Ref: FCC Class II Permissive change for FCC ID: 2AQUQGE50333

Applicant: Globe Electric Company Inc.

This is to request a Class II Permissive change for FCC ID: 2AQUQGE50333 originally granted on 02/25/2021 (date).

Component changes diagram

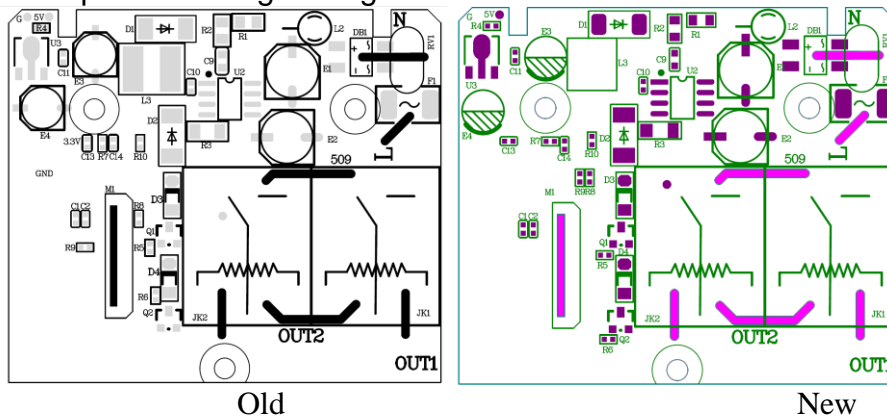
1. The package of inductance L3 from SMD/CD54 change to DIP/0810
2. The package of electrolytic capacitor E3、E4 from SMD/5*5.4 change to DIP/5*11
3. Position moved of the chip capacitor C13 and chip resistor R6、R8、R9
4. Direction changed of the chip resistor R5、R7

Circuit modification diagram
TOP layer circuit

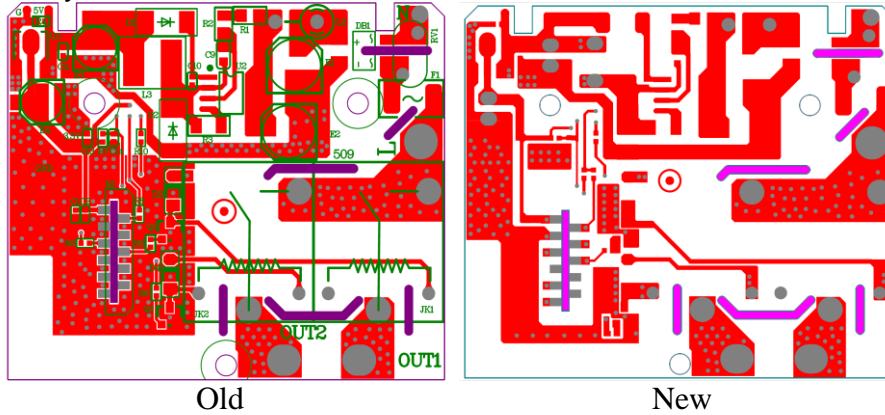
Note: Changes to the circuit on the left side of the black marking

BOTTOM circuit

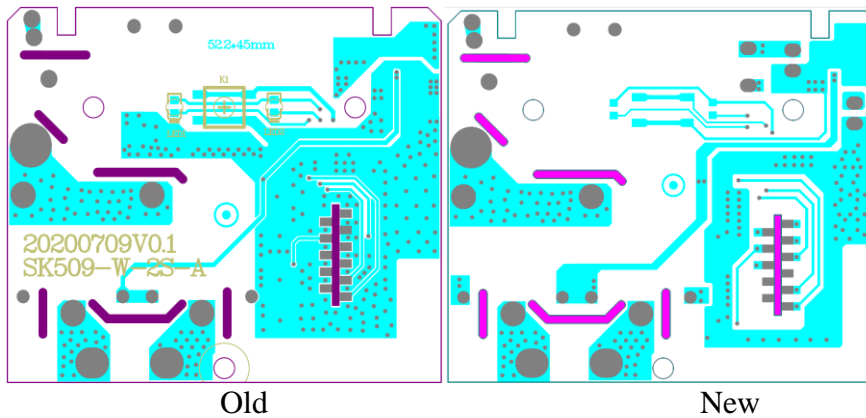
Note: The circuit modification on the right side of the black marking line
